CHANGE ORDER #1- SANITARY SEWER ALIGNMENT CHANGE

LATERAL 1, MAIN 16
OF THE FOUR MILE CREEK SEWER

SANITARY SEWER LINE NO. 2

Sheet 7 of 18
CHANGE ORDER #1

SANITARY SEWER LINE NO. 2

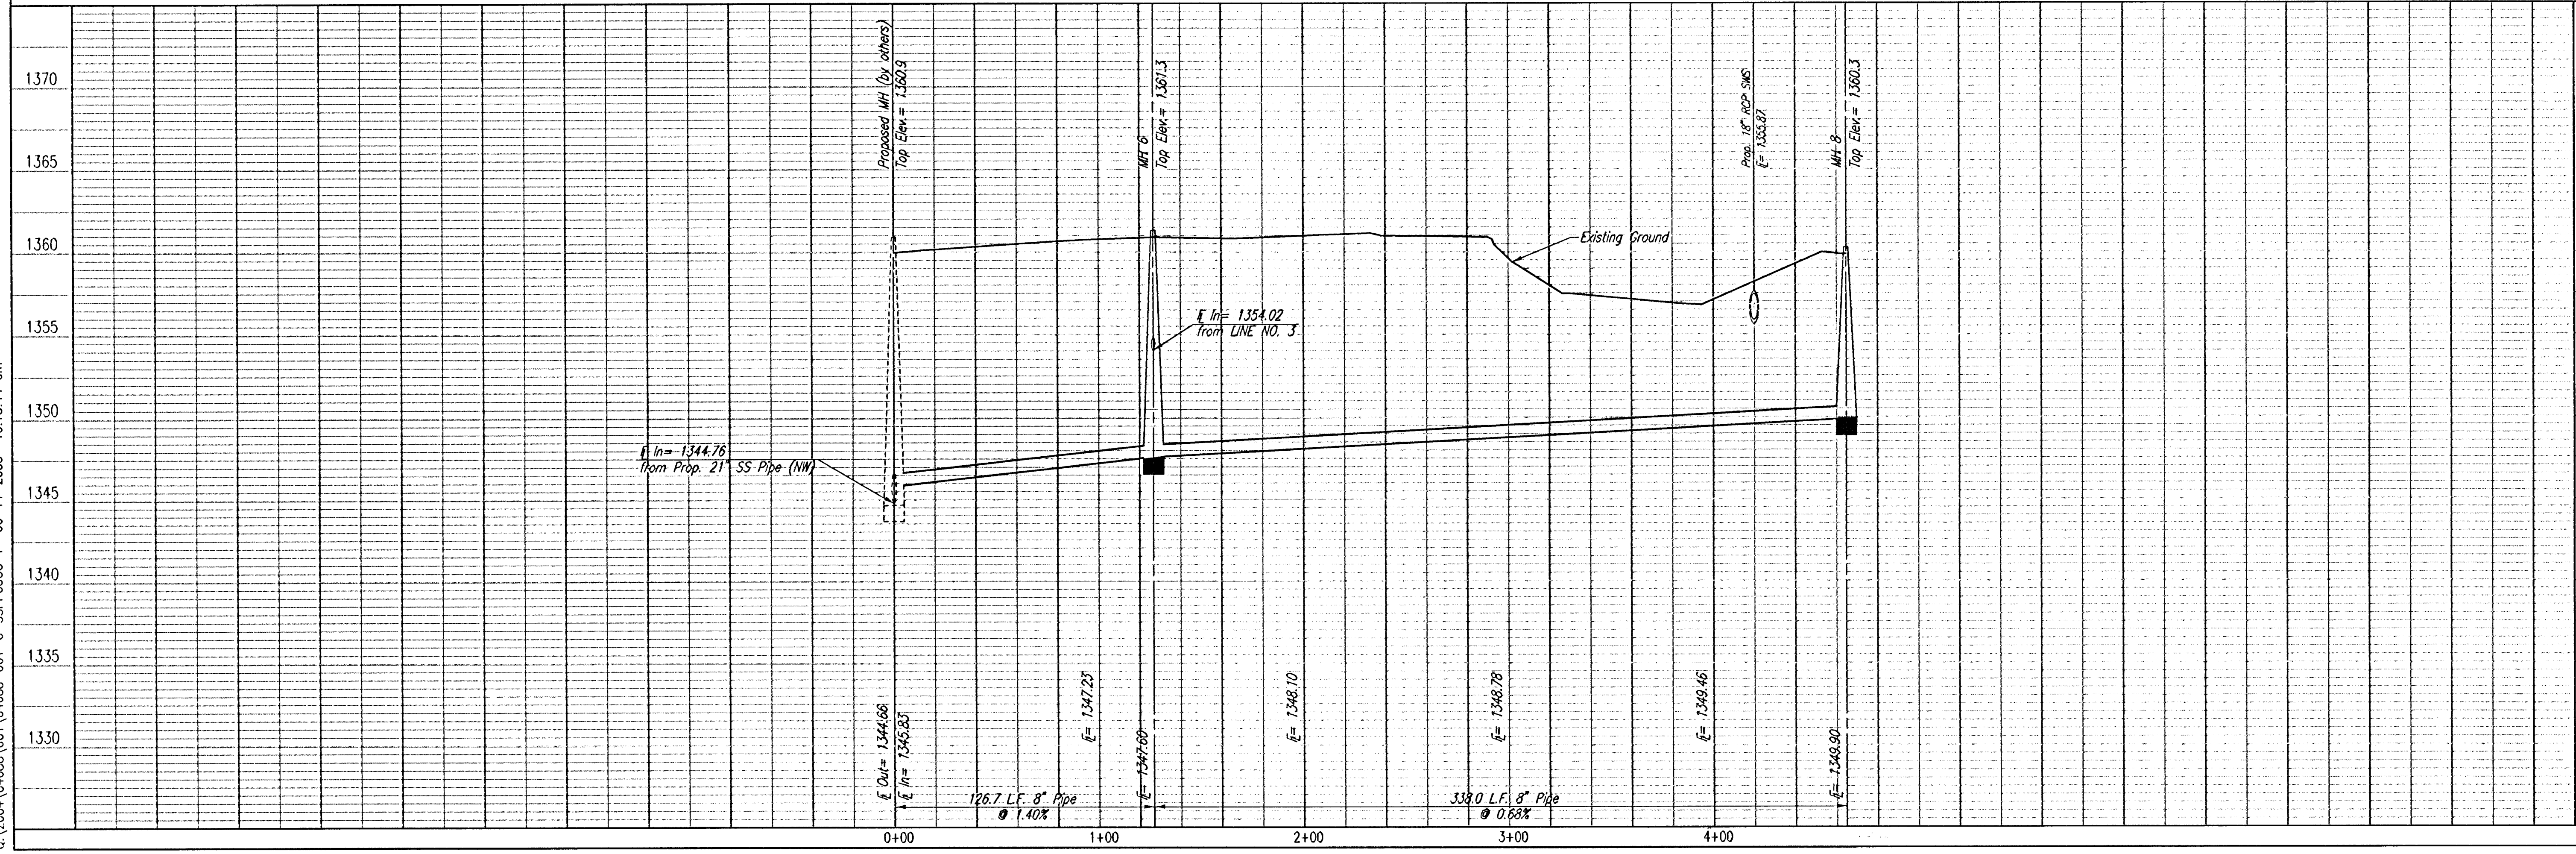
~~N-386,528.1371, E-2,373,397.1236~~
~~Sta. 2+24.2~~
~~Const. MH 7~~
~~Standard MH~~
MH 7 OMITTED
